5.3 Block Diagram

Figure 1. TIDM-1001 System Block Diagram

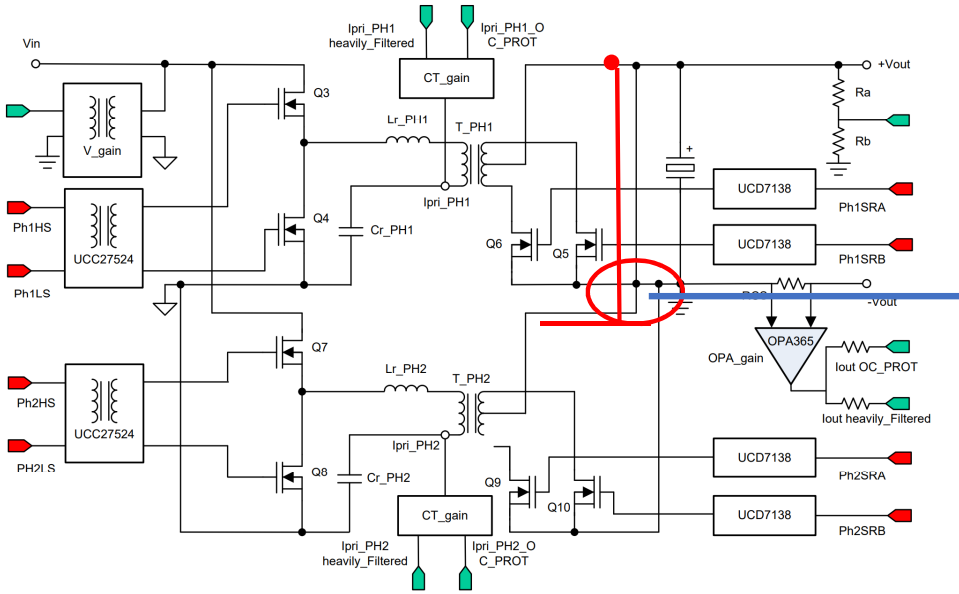
Should not the CT go to the +vout node?
